SERVICE INFORMATION

APPLICABILITY: 2015MY Forester

NUMBER: 07-92-15R

SUBJECT: Condensation (Fogging) in Rear Combination Lamps

Rear view of the new combination lamp showing the 6 additional breathing holes.

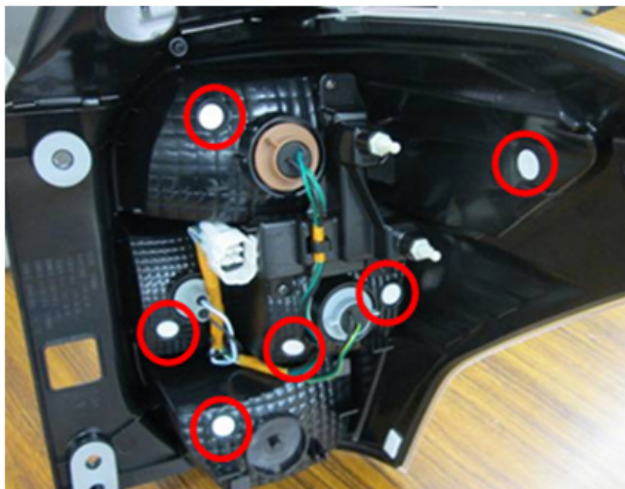
This **Service Information** bulletin announces a design change to the rear combination lamps to address customer concerns of fogging or condensation accumulating on the inside surface of the lens. Six additional breathing holes have been added to the body of the lamp assembly. The additional holes are intended to provide additional ventilation and prevent fogging which may result when severe ambient temperature changes occur.

The new combination lamps were incorporated into production starting with VIN F*530822.

PART NAME:	PART NUMBER:
LENS & BODY COMPL RH	84912SG041
LENS & BODY COMPL LH	84912SG051
